TO: Council, SSC and AP Members
FROM: Chris Oliver 
Executive Director
DATE: May 30, 2007
SUBJECT: BSAI Crab Management

Crab Plan Team Report

The team spent substantial time reviewing each chapter of the Initial Review draft of the Amendment 24 Environmental Assessment to revise the crab overfishing definitions. Comments below are organized according to chapter, with general comments on organization, revision across the Chapter (or document) listed first followed by page-specific revisions. Understanding that staff have already compiled an errata sheet to be distributed to the SSC at this meeting these corrections are not repeated here. Following a thorough review of the entire document, the team discussed the necessity of further CPT review and discussion of the analysis prior to Council final action. Accordingly, the CPT requests that the team have a chance to review the analysis in September prior to being released for the Public Review Draft.

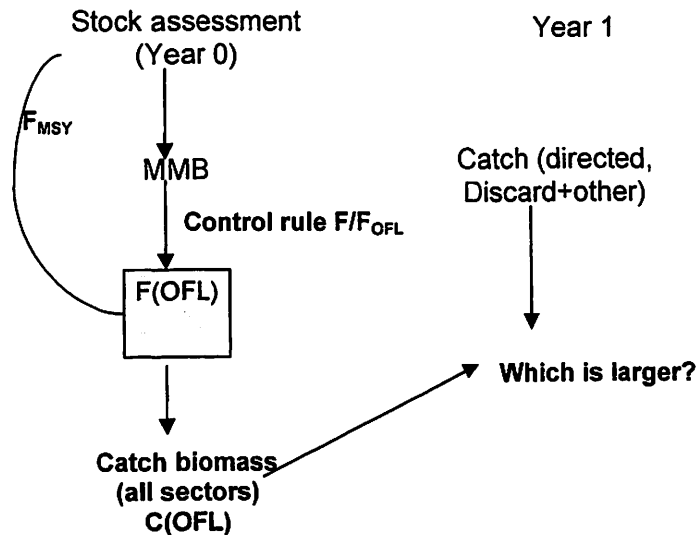
André presented a figure characterizing the process of analysis and application of the overfishing determination. A figure along the lines of that below should be included in the revised Chapter 2 to help clarify the simulation process and how (and when) this process interfaces with the stock status determination as well as at what stage (analytically) we move from MMB to total catch. This figure would need to be further modified to include the process of status determination for “overfished” status ($1/2 B_{MSY}$) as well in Year 0.

Add total removals to clarify that 06/07 F is for the directed fishery only, but that the OFL should include removals from other fisheries. Rearrange this table so it is clear what aspects are related to OFL determinations under alternative 1 (through $OFL(06)=SY$) and what is a separate cataloguing of “what happened” which includes TAC column and 06/07 F rate column. This table should be revised by analysts for presentation to the SSC in June for clarity. This table is intended to compare results across the six surveyed stocks only.

Figure 6. Bristol Bay commercial red king crab general/IFQ and CDQ fishery harvest and guideline harvest levels, 1993-2005/2006.

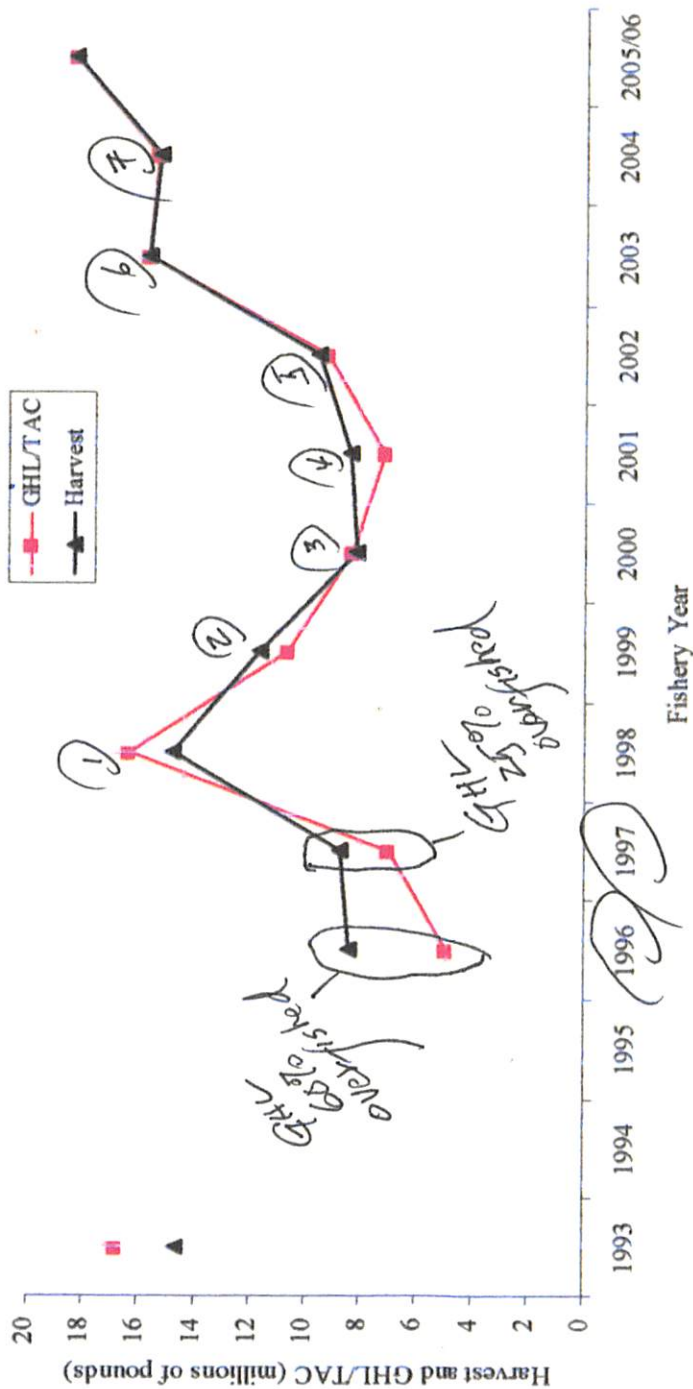
REQUEST: NPTMC ADVISES CPT TO ANALYZE THESE OVER-FISHING IMPACTS BY DEC'07 MEETING
4-9
